Technical Memo

To Ken Clayton, Jon Hotaling, Panadero Ski Corporation
From: Mike Deiparine, PE
Jamie Bunch, PE
Date: August 22, 2023
Project: Cuchara Chair 4
Subject Entrance Beam Failure and field observations

Figure 1 Lower Terminal Portal Structure Deformed

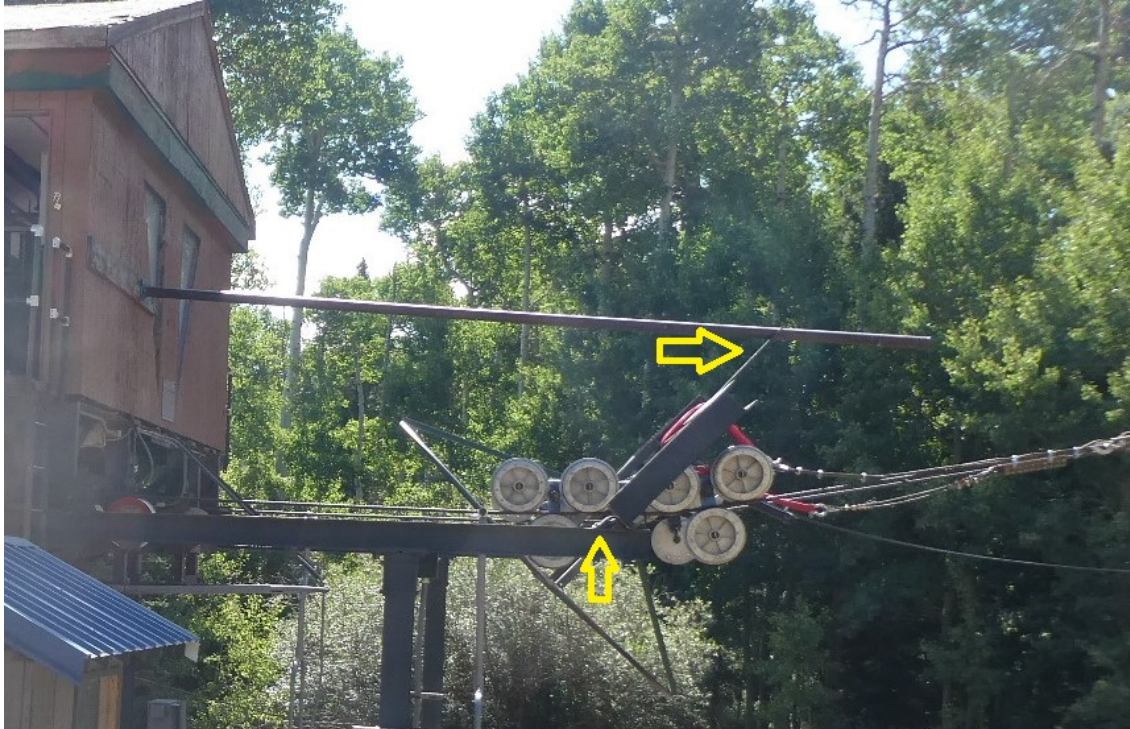
Panadero Ski Corporation (Client), acting as a lessee of property and chairlift equipment from Huerfano County, CO, has been in the process of refurbishing an abandoned chairlift formerly owned by the Cuchara Ski Area, near La Veta, CO. During the process of performing mechanical maintenance, a mechanical incident occurred resulting in damage to the support frame of the entrance beam at the lower terminal. According to statements by Client staff, the incident occurred on July 29, 2023. Client has contracted with SCJ Alliance (SCJ) to provide forensic investigation and assessment of the incident and resulting damage to the equipment.
